**AGENDA
TOWN OF PITTSFORD
PLANNING BOARD
AUGUST 28, 2023**

**Re: Coventry Ridge Section 4
Final Subdivision Application**

**Re: Coventry Ridge Section 4
Preliminary Subdivision Conditions of Approval
Response to Comments**

COVENTRY RIDGE SUBDIVISION

PROJECT MANAGER: P. VARS
 PROJECT SURVEYOR: GO BELL
 DRAWN BY: BC GOODING
 SCALE: 1"=50'
 DATE ISSUED: FEBRUARY 1, 2023
 PROJECT NO.: 9502G
 DRAWING NO.: 03

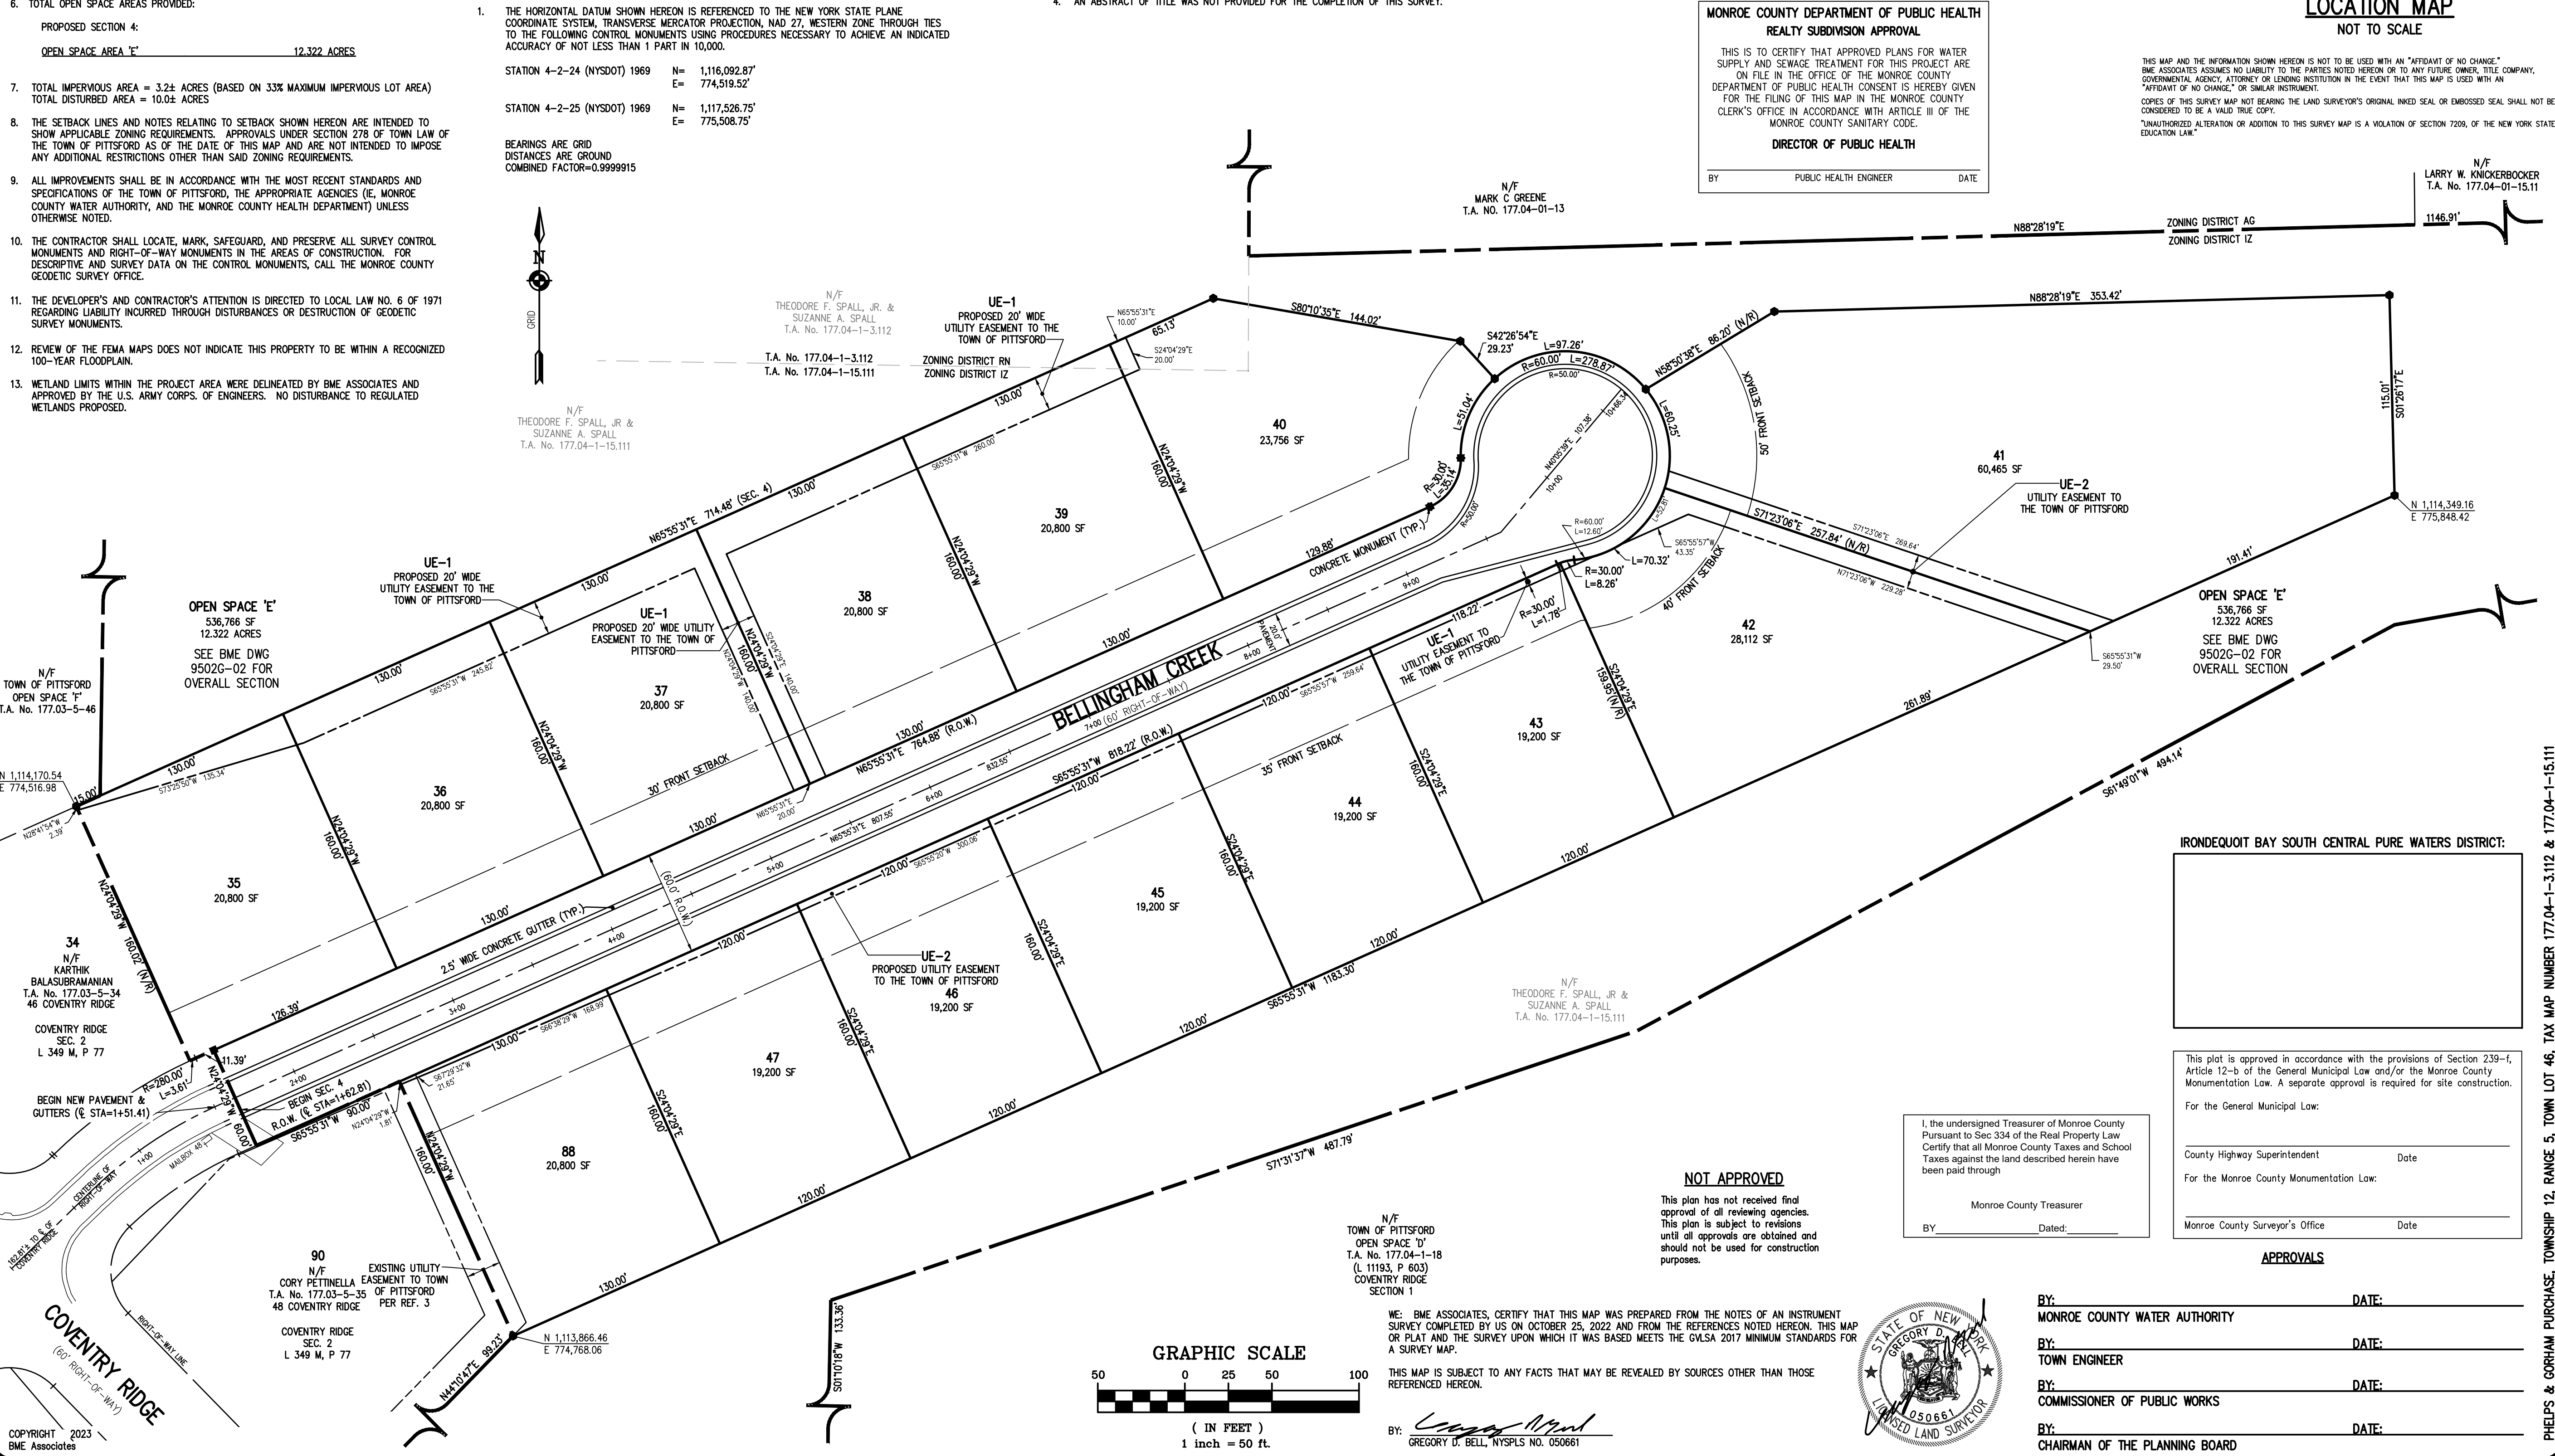
3. Final plans must include open space monuments shown on lot property corners.

The Subdivision Plan, BME Drawing Number 9502G-03, has been revised to include Open Space Monument locations, as requested.
